CONTRACT ADDENDUM

GLYNN ARCHER DRIVE/ 14TH STREET ROADWAY RECONSTRUCTION FROM NORTH ROOSEVELT BLVD. TO FLAGLER AVENUE

Project No. EN-1004
(Lap Agreement FM #420042-1)

Addendum No. 3

1

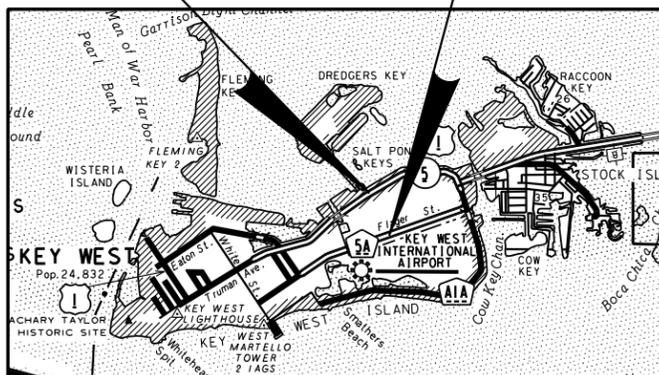
KEY SHEET REVISIONS	
DATE	DESCRIPTION
02/29/12	REVISED GOVERNING STANDARD NOTES

ROADWAY PLAN

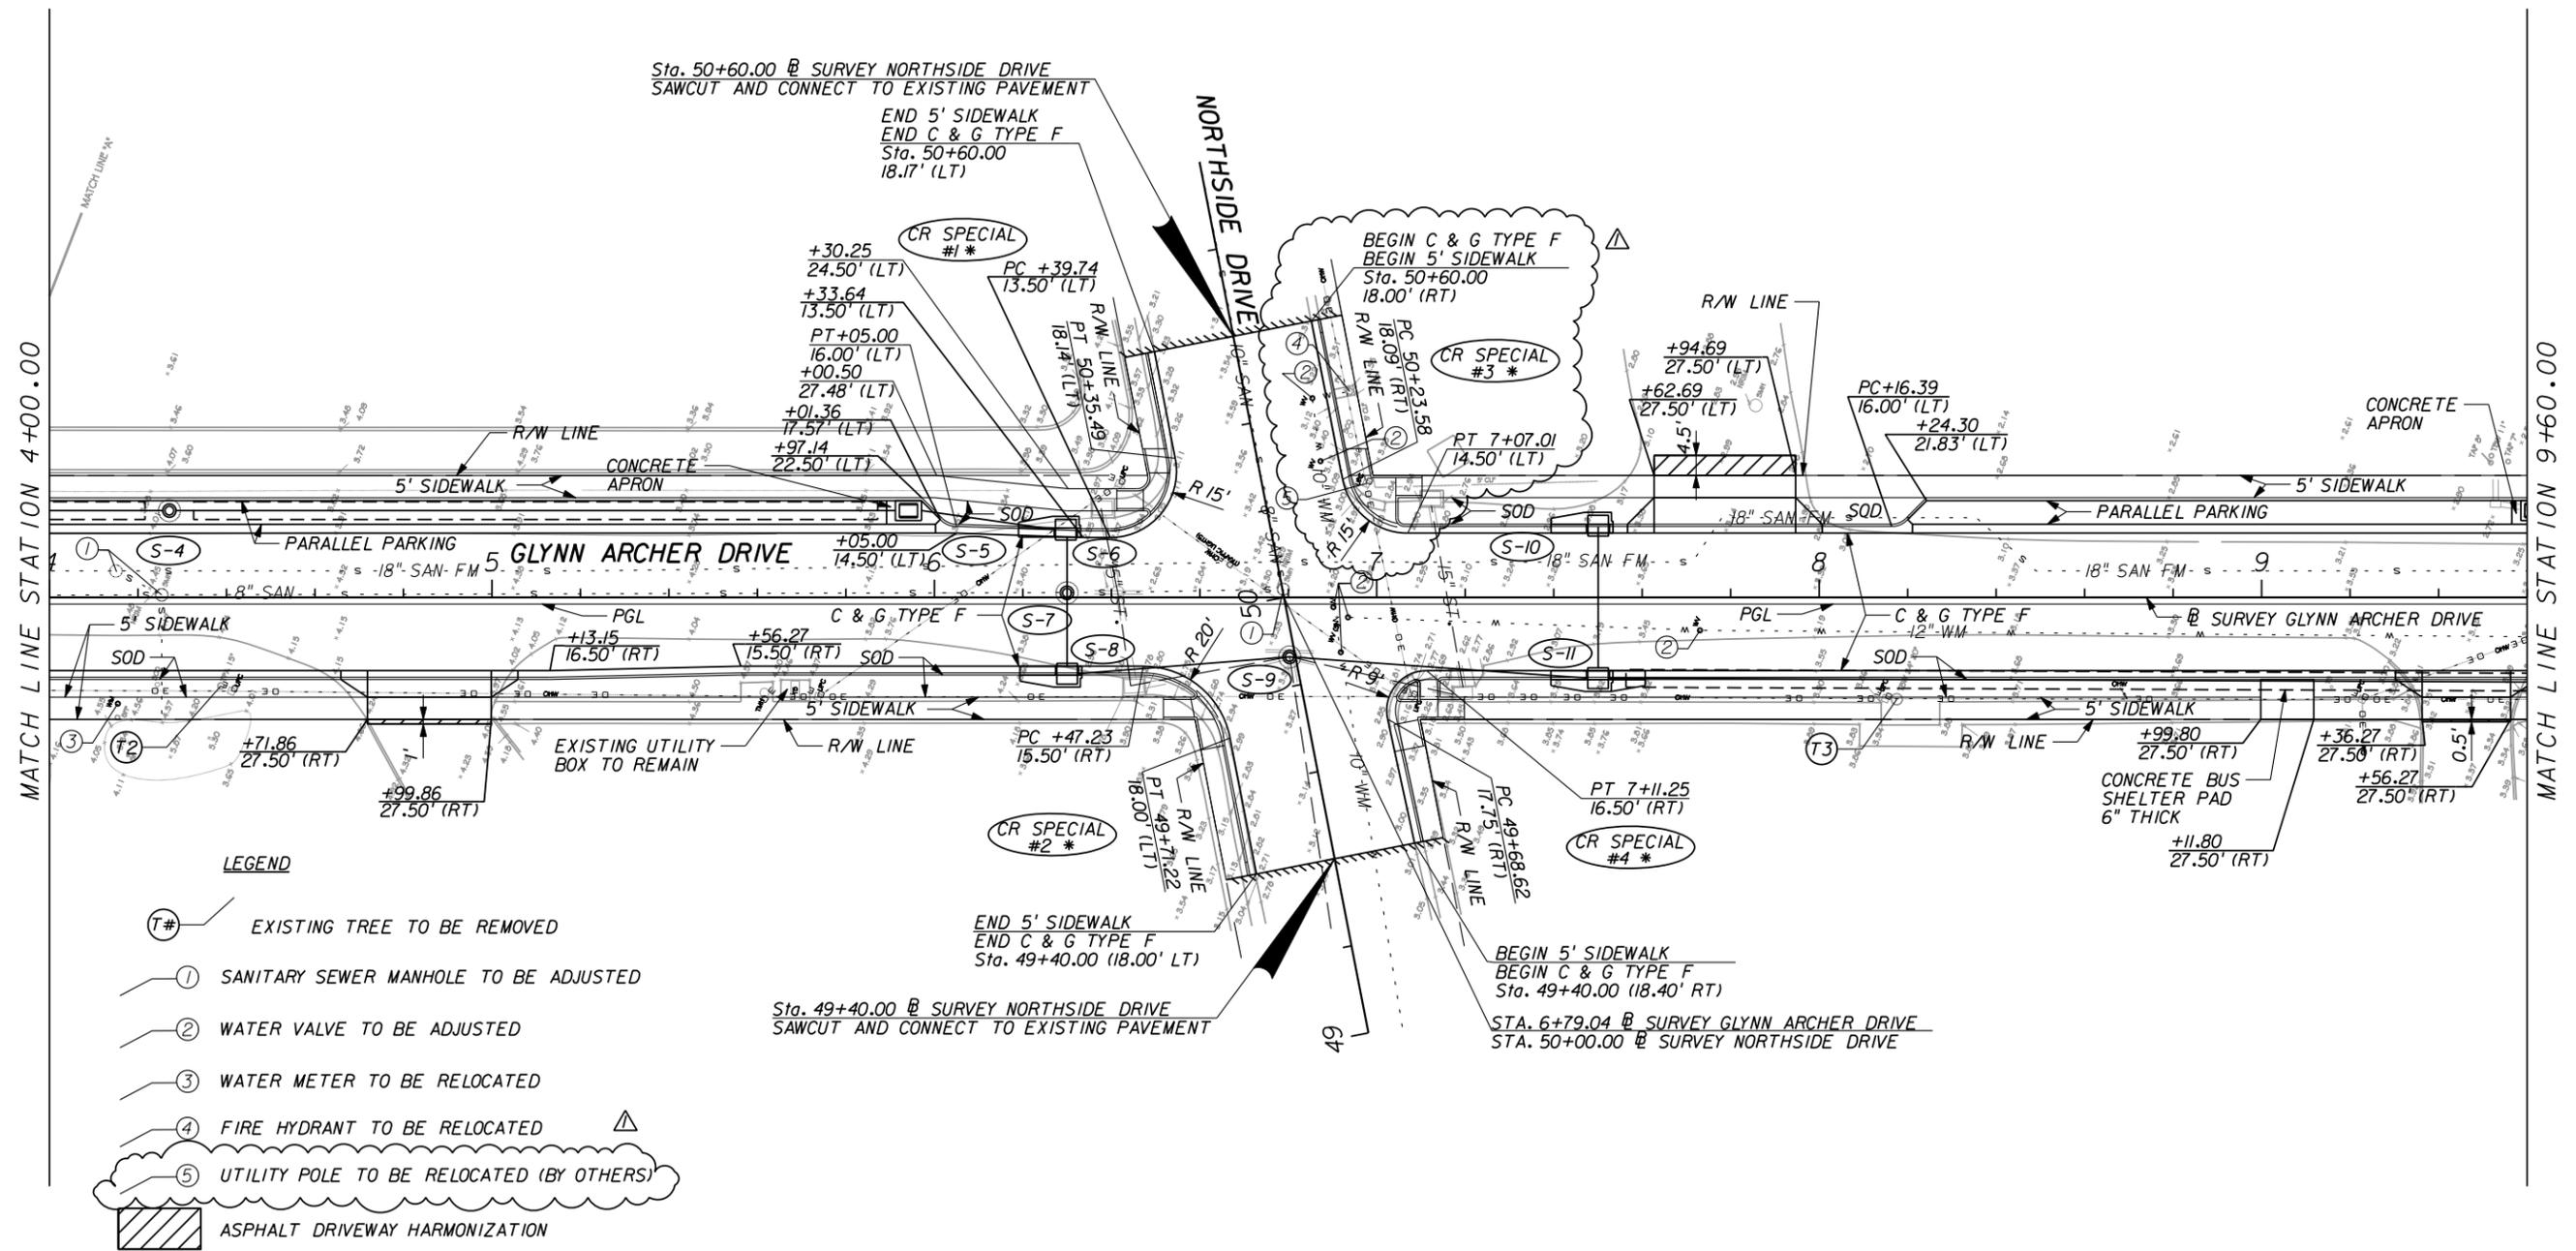
REVISIONS	
DATE	DESCRIPTION
02-29-12	CEV Δ MODIFIED CURB RAMP AND SIDEWALK LIMITS

SHEET NO.
 18

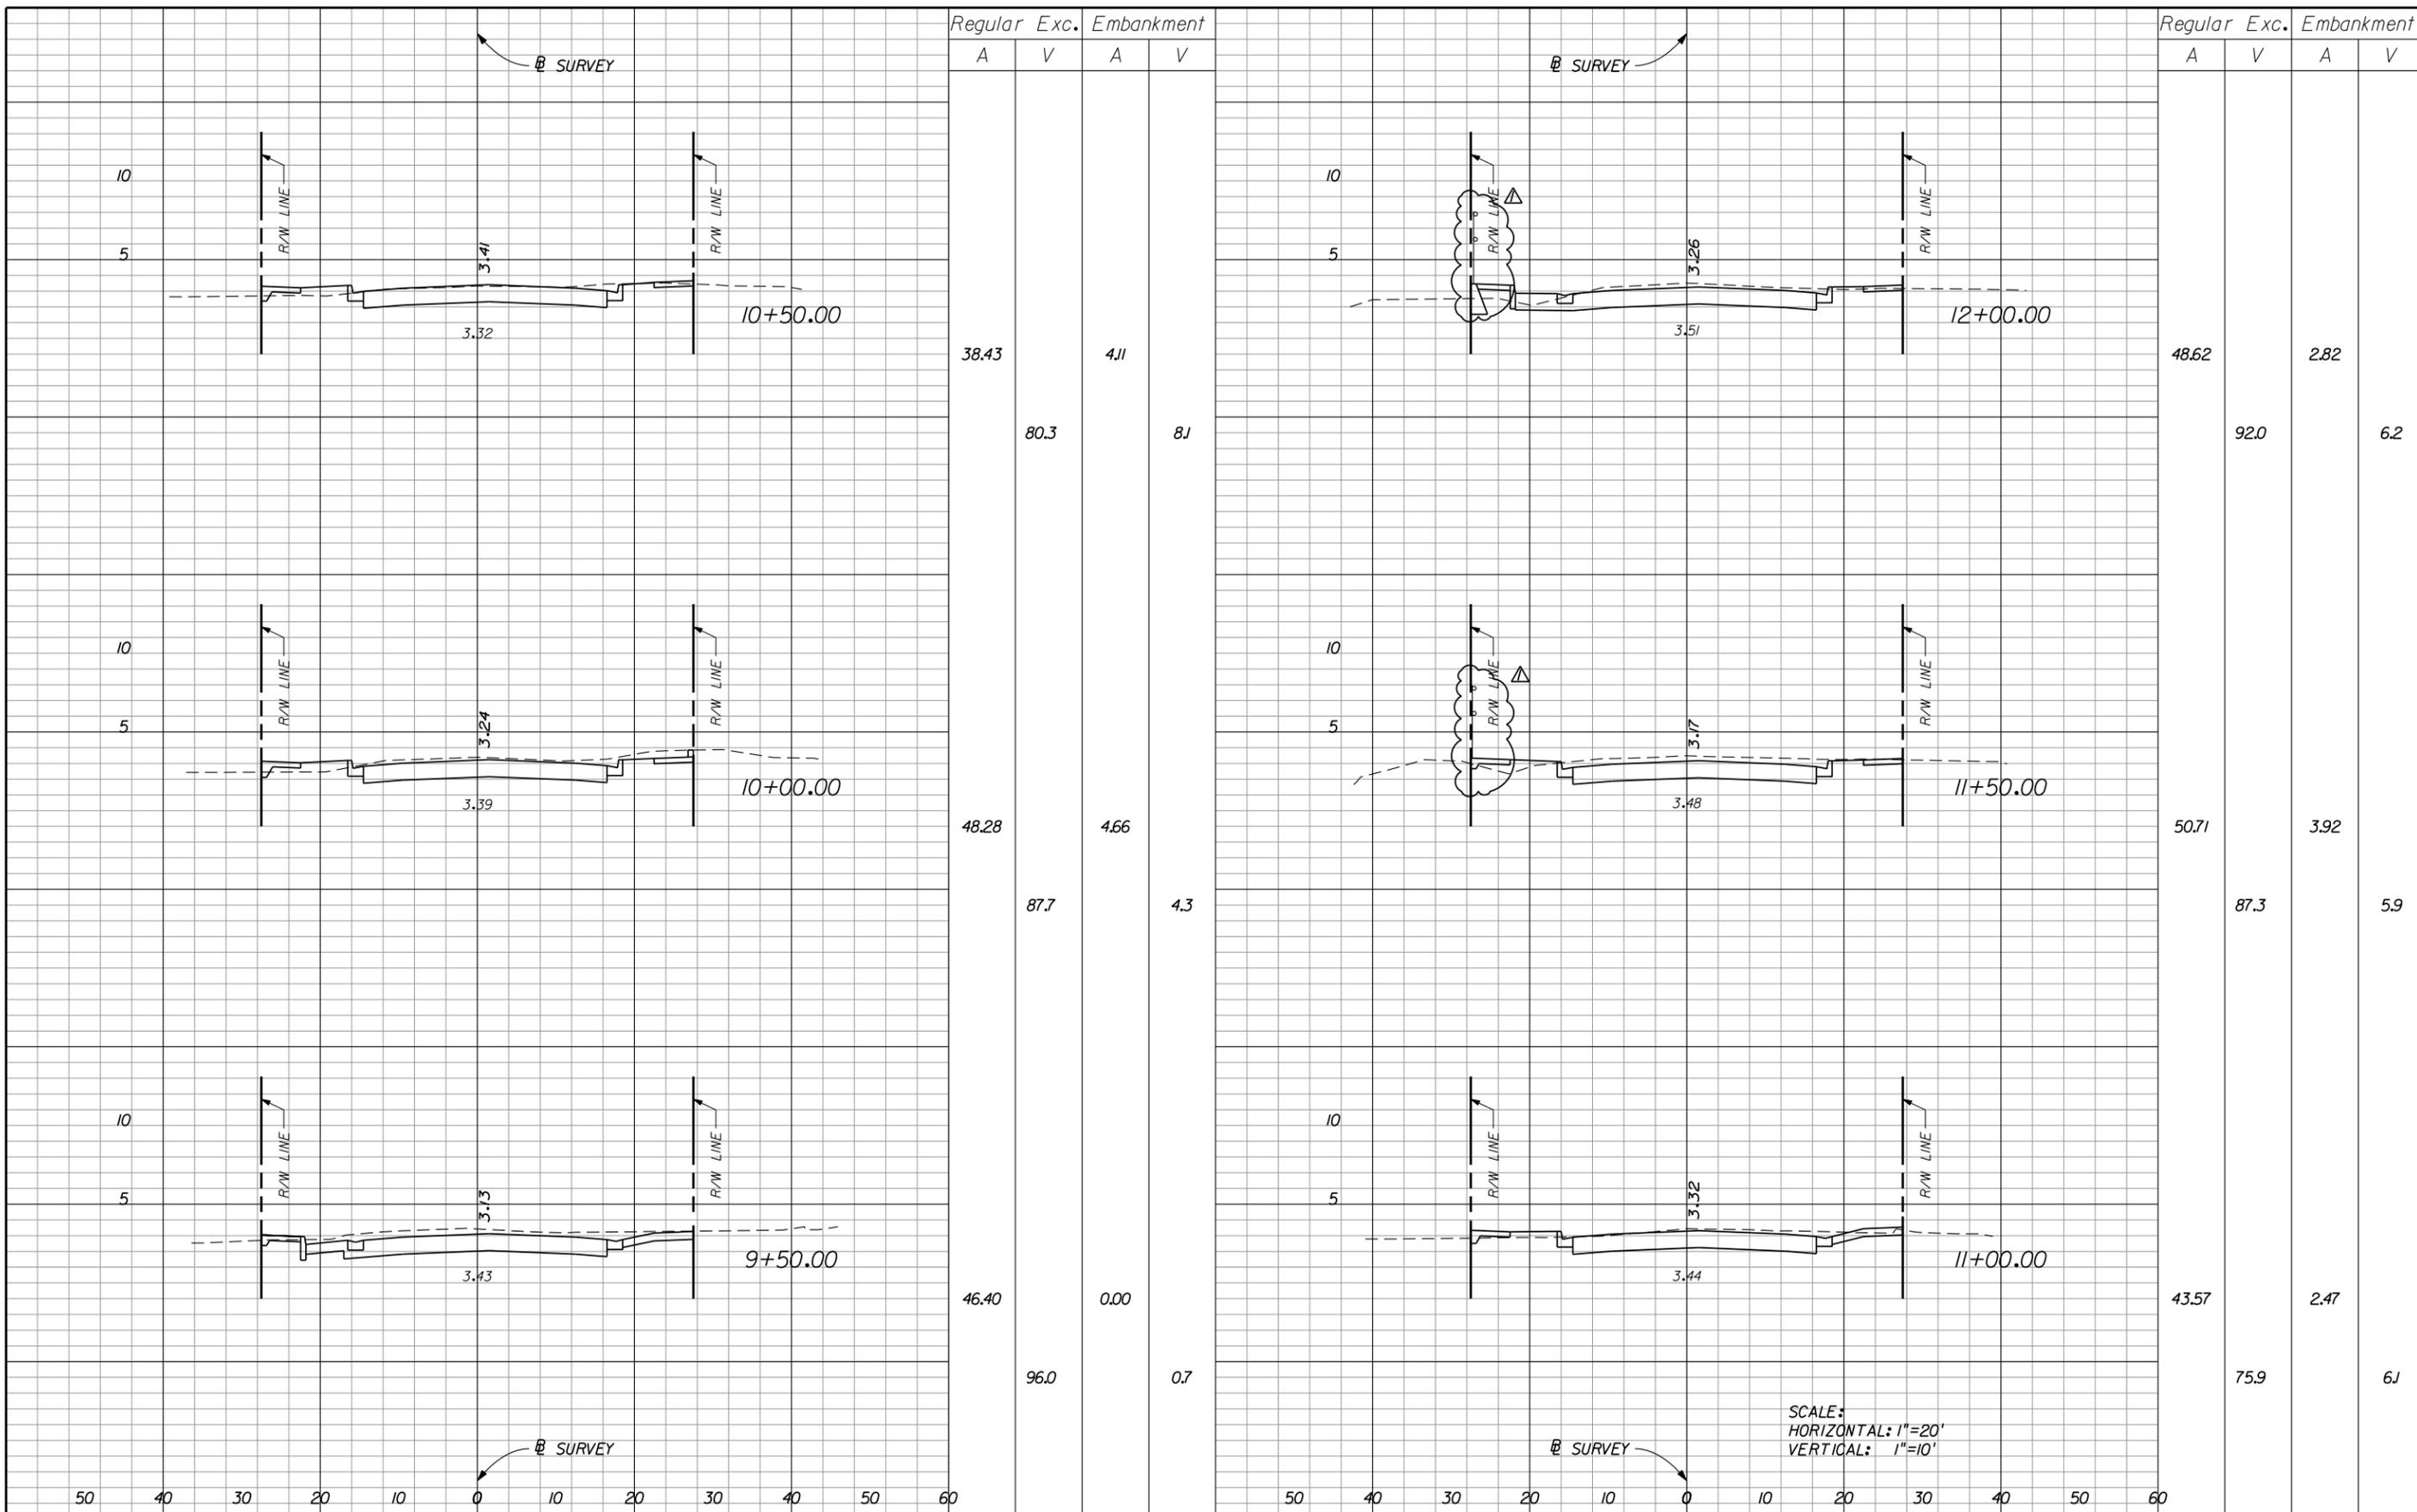
REVISIONS			
DATE	DESCRIPTION	DATE	DESCRIPTION
02-29-12	CEV Δ MODIFIED CROSS SECTIONS

CROSS SECTIONS
 SHEET NO.: 30

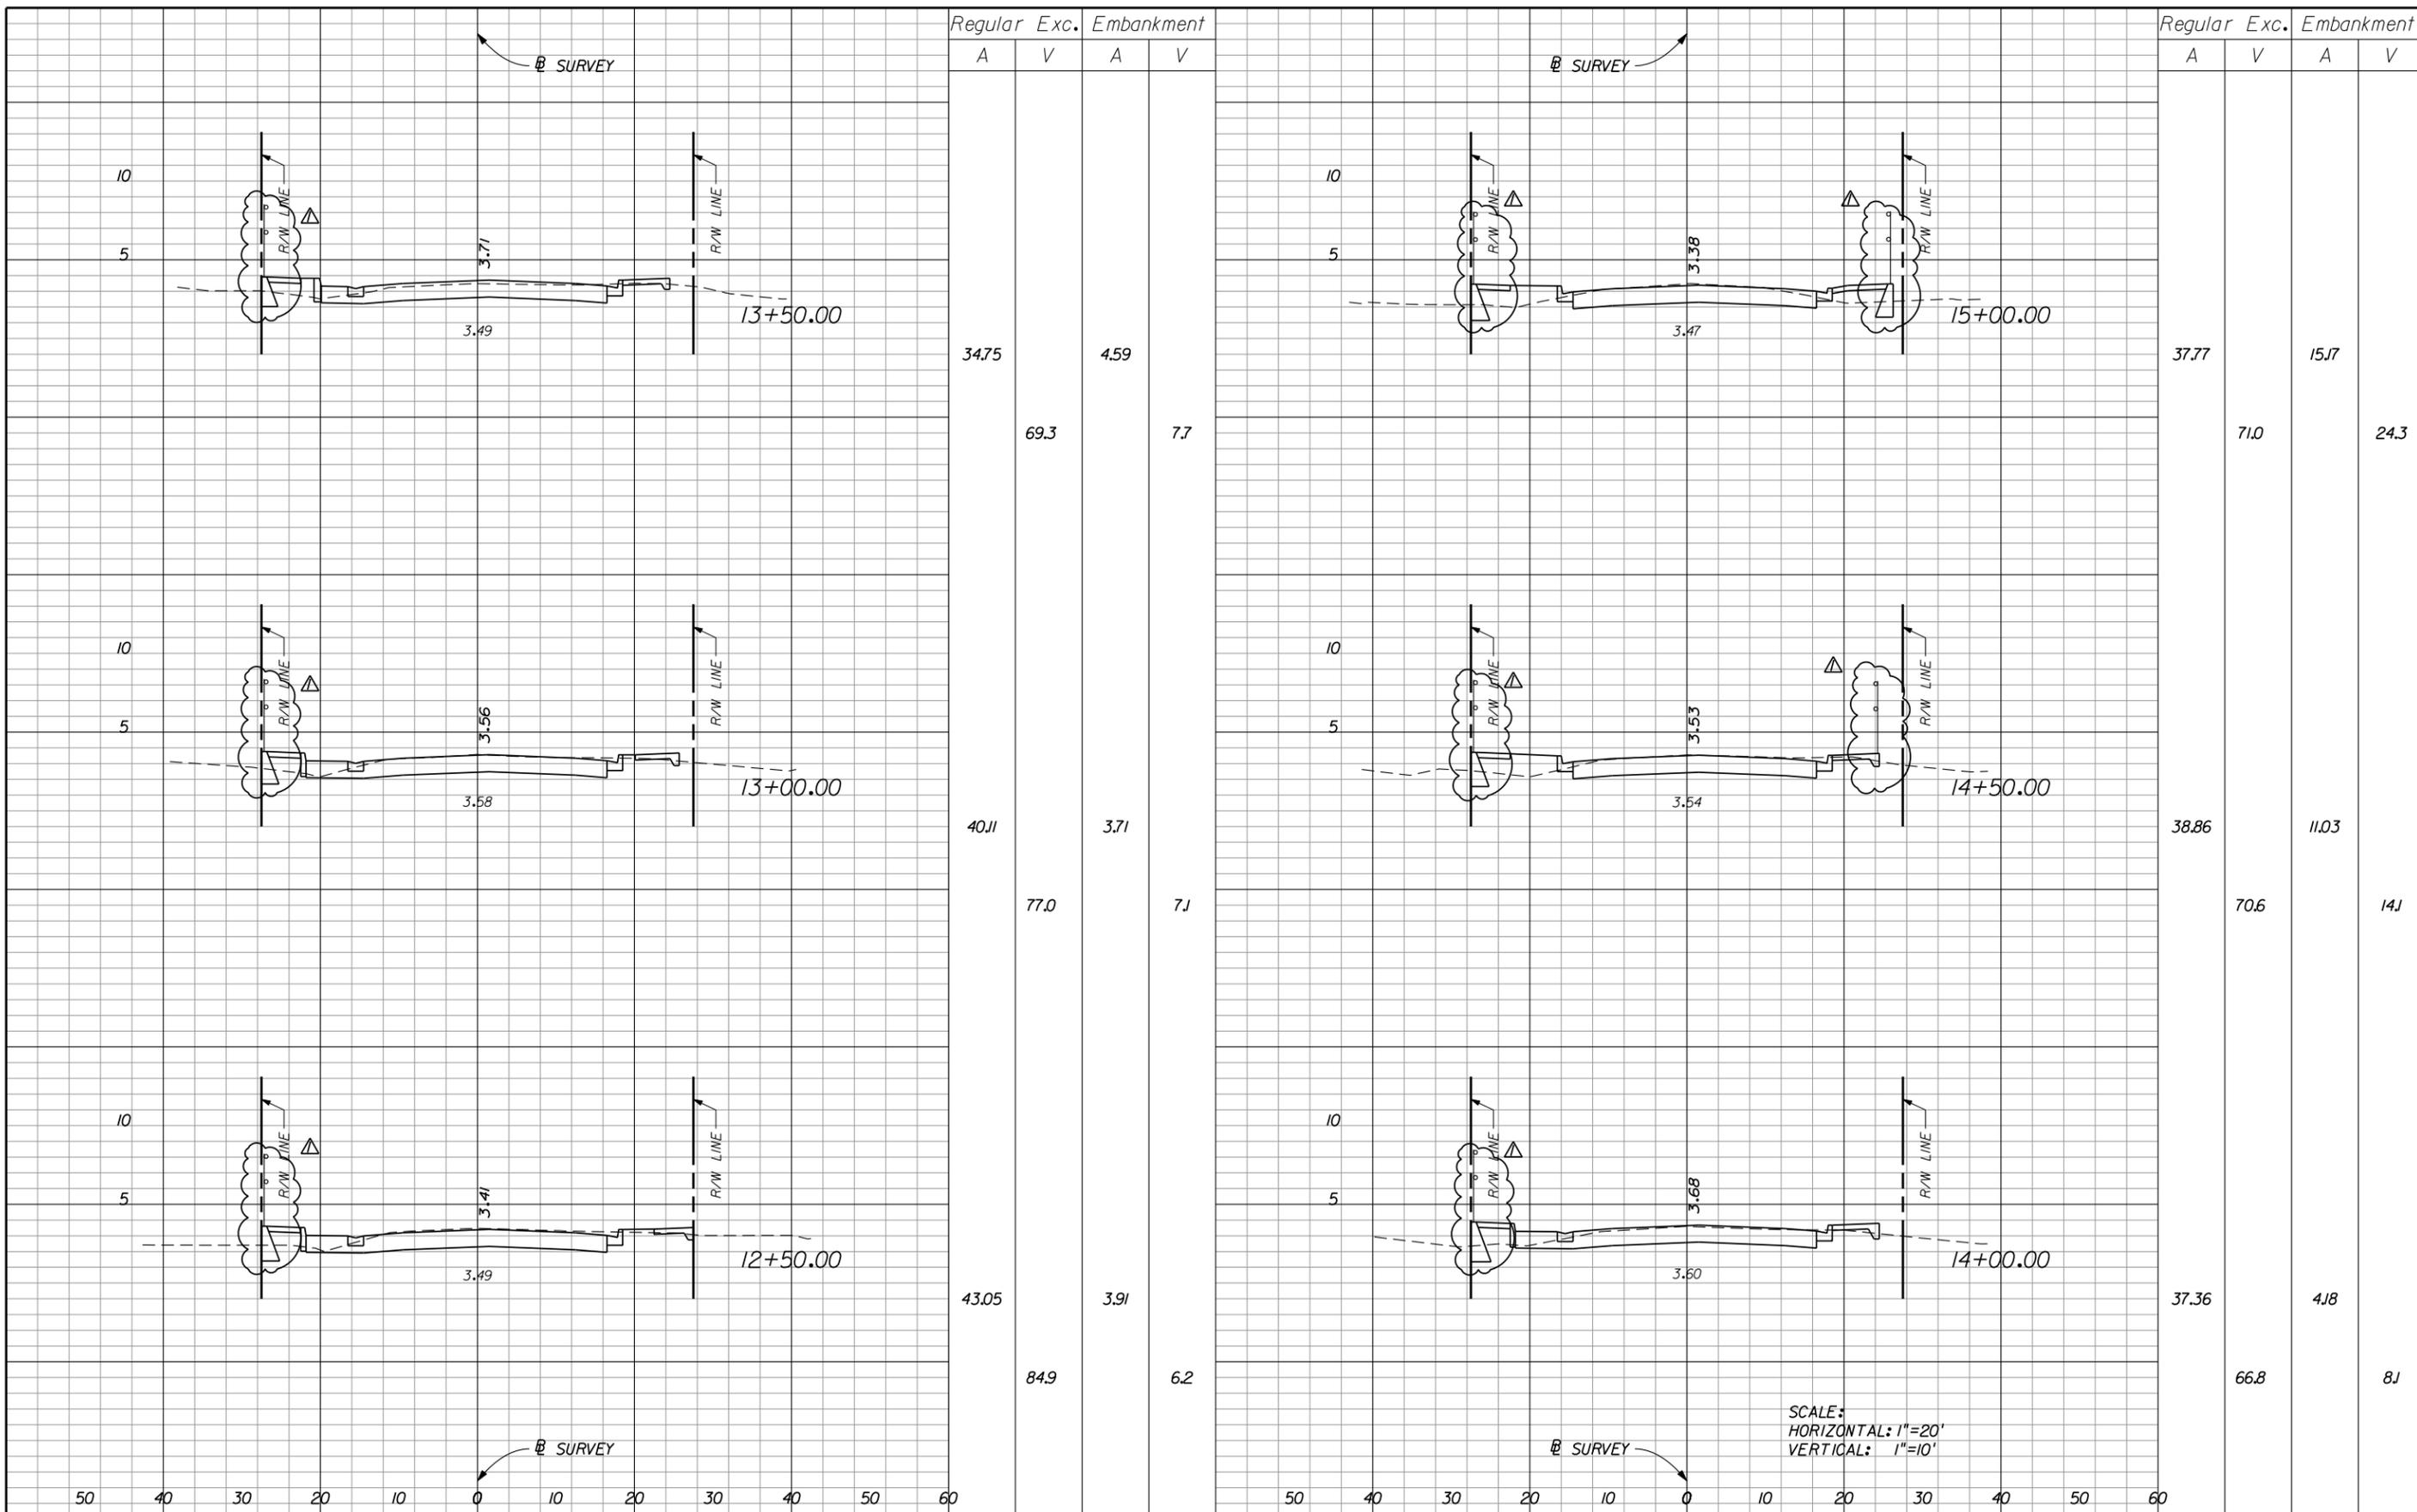
REVISIONS			
DATE	DESCRIPTION	DATE	DESCRIPTION
02-29-12	CEV Δ MODIFIED CROSS SECTIONS
